Summerlin West Village 22-Kettle Ridge Drive
(Sheet J)

CITY OF LAS VEGAS INTER-OFFICE MEMORANDUM			DATE: January 21, 2021
TO: Land Development Services Department of Building & Safety			FROM: Albert Sung, P.E. Flood Control Project Engineer Department of Public Works
SUBJECT: Drainage Study for: Summerlin West Village 22 - Kettle Ridge Drive (Street J) (from Sunset Run Drive to Kindle Rise Way)			COPIES TO: Atkins Global
Cross Streets:	Kettle Ridge Drive and Sunset Run Drive		Howard Hughes Company, LLC.
File Number:	F:\Depot\DSMemos\DS5349C.doc		Bart Anderson, P.E., DevCo
Parcel Number:	137-23-210-001		CCRFC
Zoning Action:	N/A		
FEMA Flood Zone	YES	NO X	
Proposed Storm Drain	YES X	NO

Supplement to Addendum #1

RE: Supplement to Addendum 1 to the Technical Drainage Study for Summerlin West Village 22 Kettle Ridge Drive: Sunset Run Drive to Kindle Rise Way

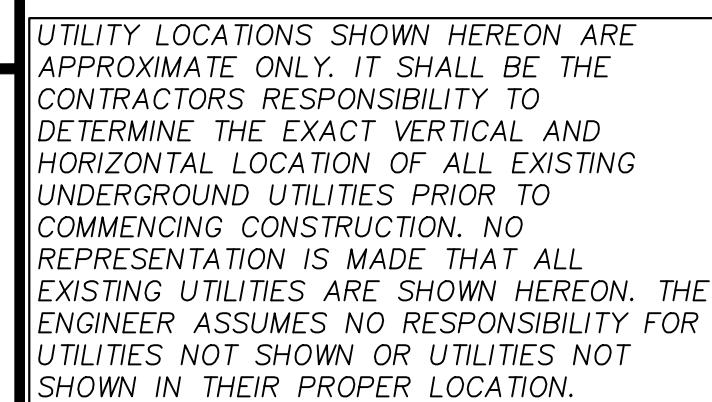
Comment #5: Previous Comment: Sheet 8/26 & Sheet 9/26: SDDI #1 appears to be at a local low point. Address in the next submittal during a worst-case scenario that the inlet is totally clogged, what is the maximum ponding depth at the inlet before it overflows. Note that the maximum allowable ponding depth is six inches. Provide enough grade elevations in the plan & profile to verify that the criterion will be met.

4. All storm drain inlets that are more than 10'-deep require a special structural detail and calculations. Submit structural design and calculations to *City Building & Safety Department* for review and approval prior to the final approval of the drainage study.
5. **Previous Comment: Sheet 8/26 & Sheet 9/26: SDDI #1 appears to be at a local low point. Address in the next submittal during a worst case scenario that the inlet is totally clogged, what is the maximum ponding depth at the inlet before it overflows. Note that the maximum allowable ponding depth is six inches. Provide enough grade elevations in the plan & profile to verify that the criterion will be met.**

The response did not clearly explain what will happen if the inlet is 100% clogged. Note that the inlet is in a low point, it doesn't look like the ponding water (in case the inlet is totally clogged) have any emergency overflow path, ie, the worst case situation can be disastrous.

Comment response: In the worst-case scenario that SDDI #1 is 100% clogged, SDDI #1 will flood-route east to SDDI #2. The centerline of roadway in the crown between SDDI #1 and SDDI #2 is 3452.70 ft, while the top of curb behind SDDI #1 is 3452.75 ft. Therefore, the flow would flood-route towards SDDI #2 before it overtops the curb. Also, the maximum ponding depth from flowline at SDDI #1 (3452.25 ft) to centerline flood-routing (3452.70 ft) is less than six inches. In the worst-case scenario that SDDI #2 is also 100% clogged, SDDI #2 then flood routes south along Kettle Ridge Drive to Sunset Run Drive, which then flows east.

CLV	00-00000	JOB NO. 100066768	DESIGNED BY: N. BARCOS
		DATE: NOVEMBER, 2020	DRAWN BY: L. MAMAOLAY
		DRAWING NO.	CHECKED BY: P. BATES
		20/29	HORIZ.: NONE VERT.: NONE

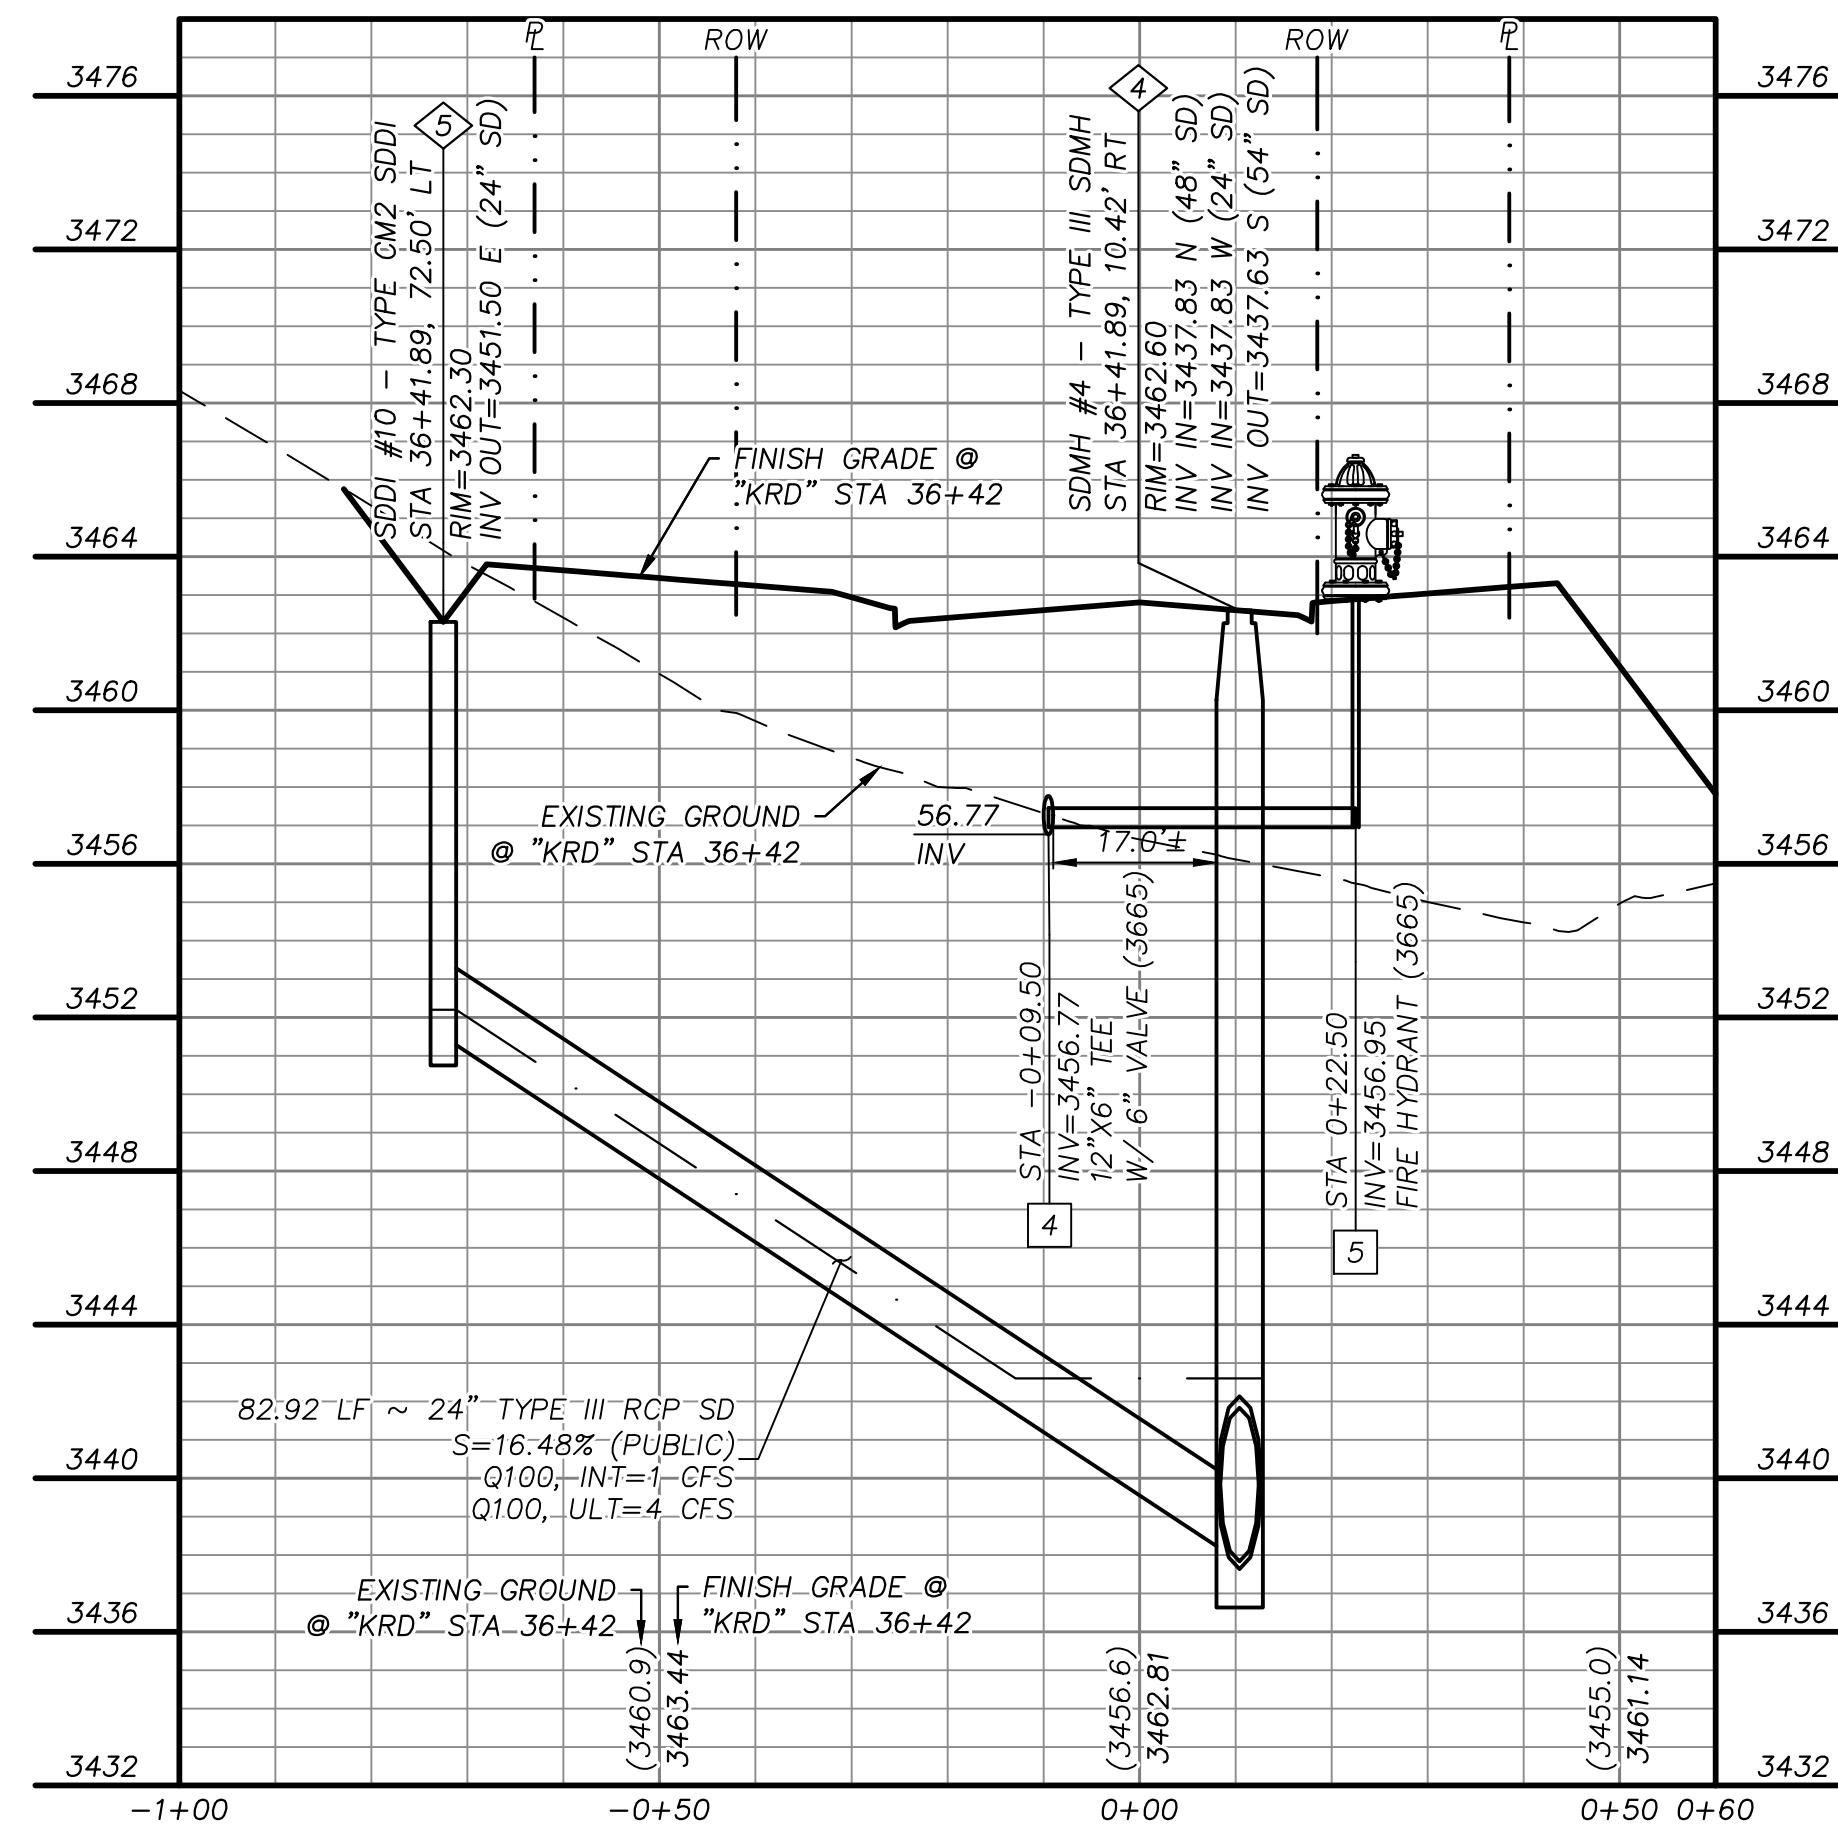
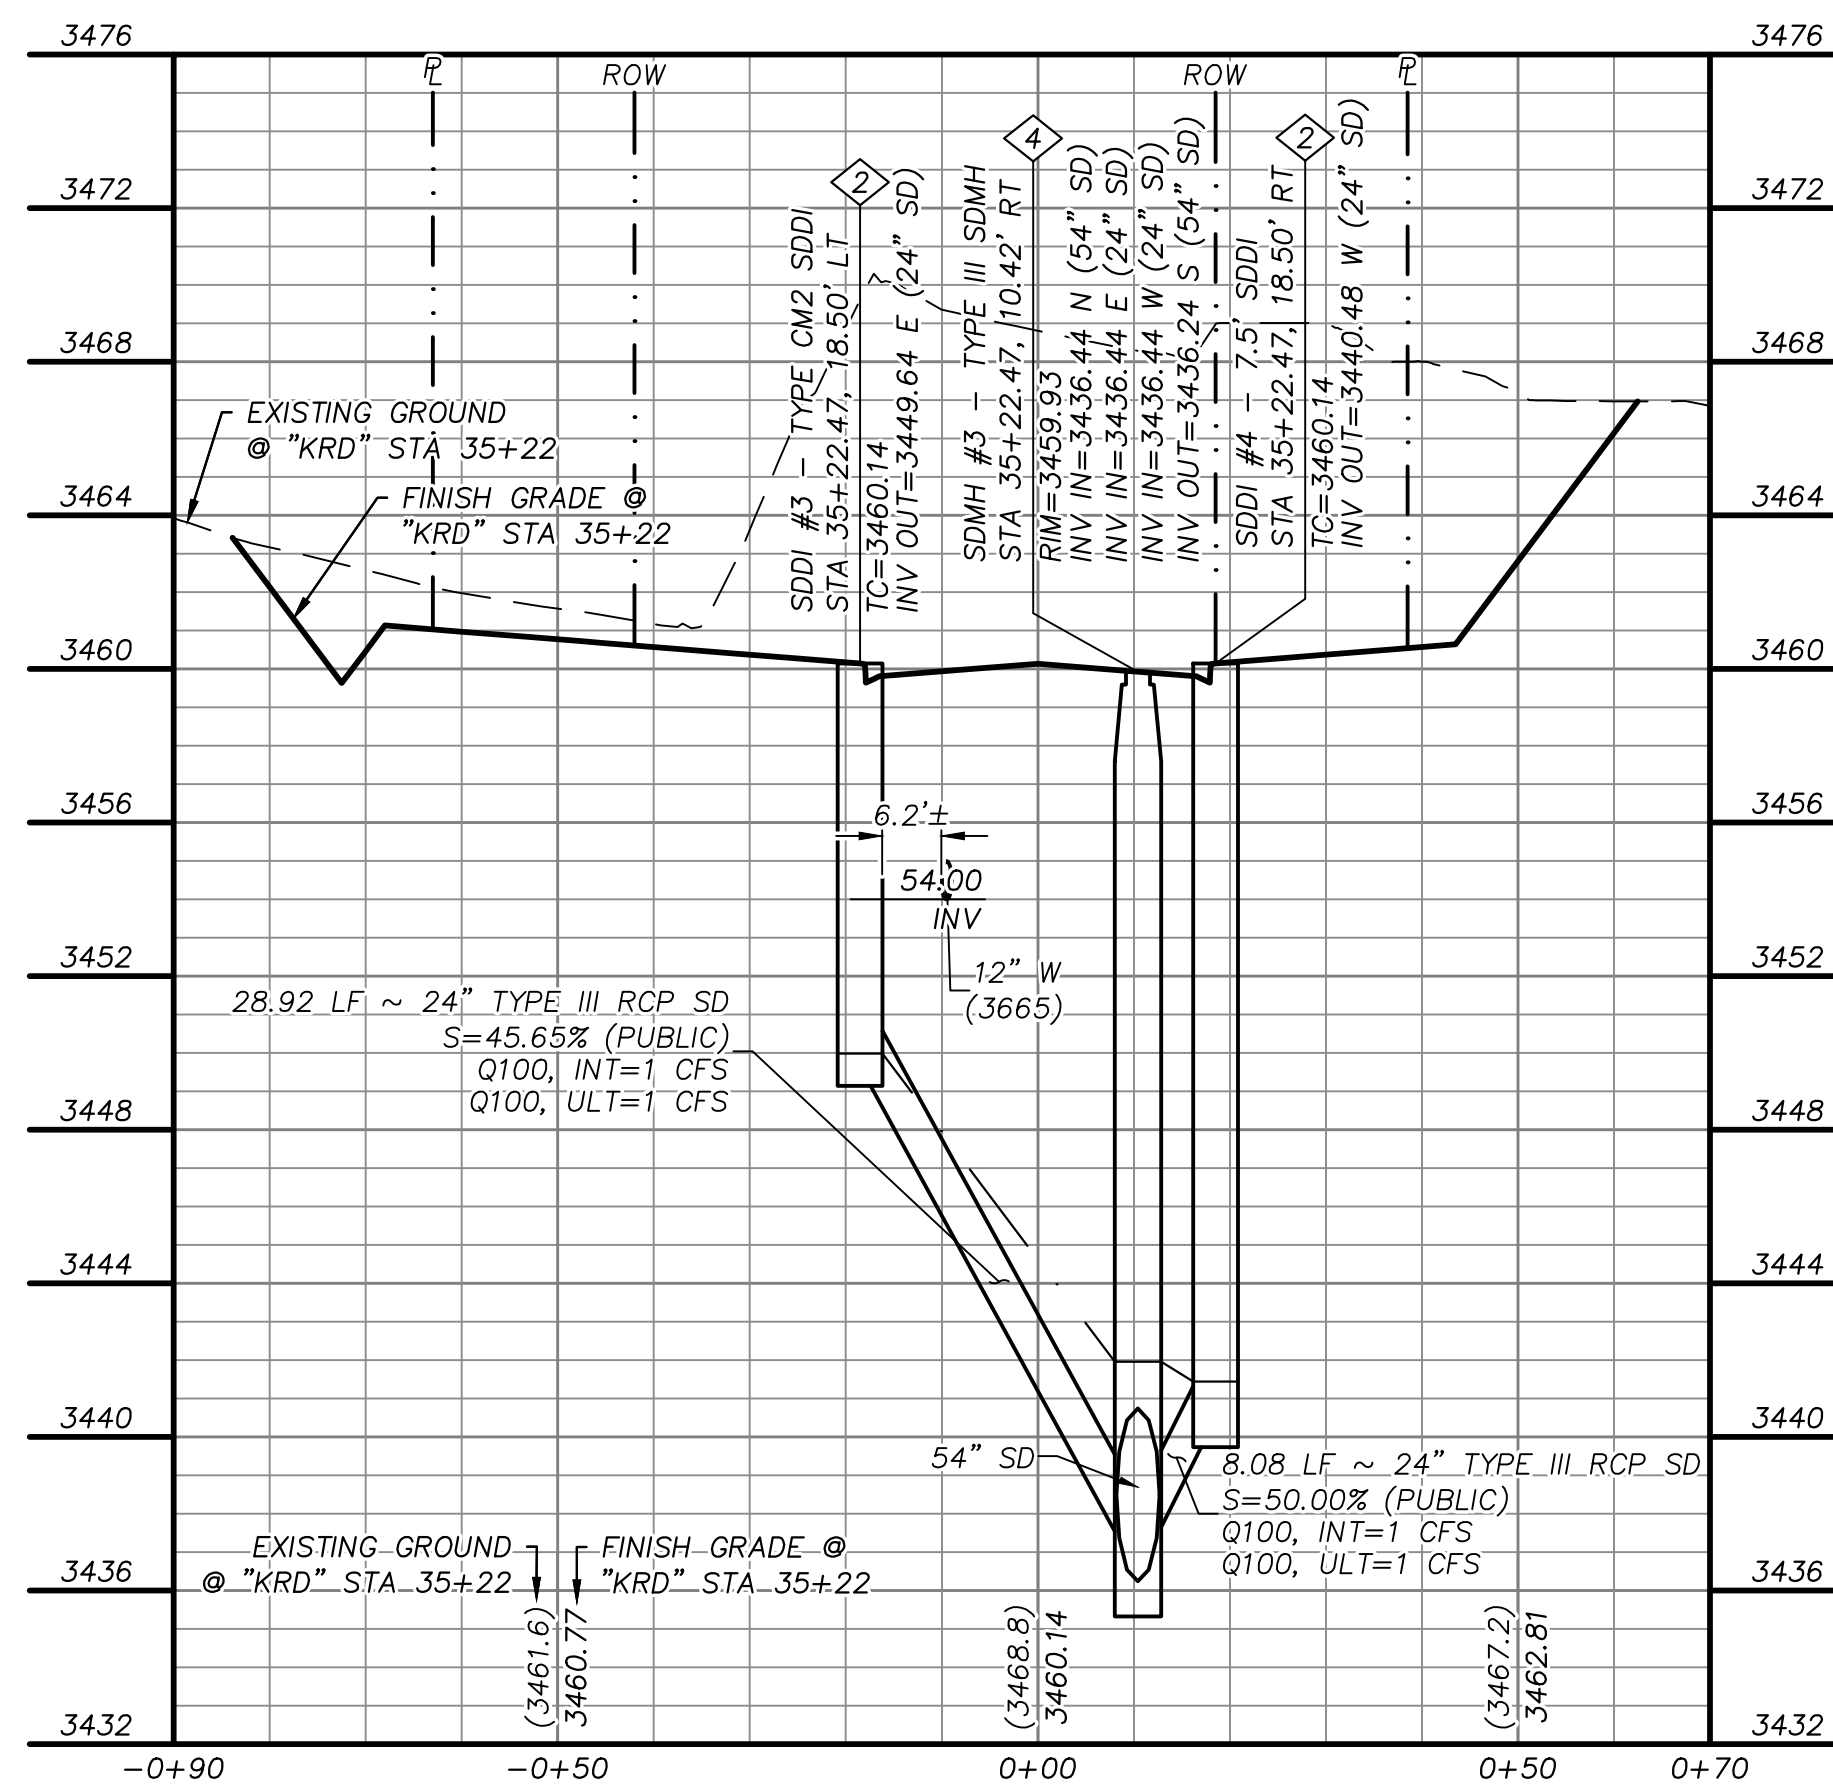
Comment #6: Previous Comment: Sheet 20/26 & Sheet 21/26: In general, the HGL shown on the profiles for the laterals do not match the calculations. For example: The HGL is lower than the base of the inlet for SDDI #10.

6. **Previous Comment: Sheet 20/26 & Sheet 21/26: In general, the HGL shown on the profiles for the laterals do not match the calculations. For example: SDDI #2: Calculation shows a lower water surface while the profile shows a much higher water surface. SDDI #5: The HGL is even lower than the base of the inlet. Same for SDDI #10.**

The response to SDDI #10 is still un-satisfactory: The HGL is still lower than the base of the inlet. Perform better quality control in the next submittal.

Comment response: SDDI #10 lateral has been revised to show the correct HGL. The associated WSPG-W output is included for review convenience.
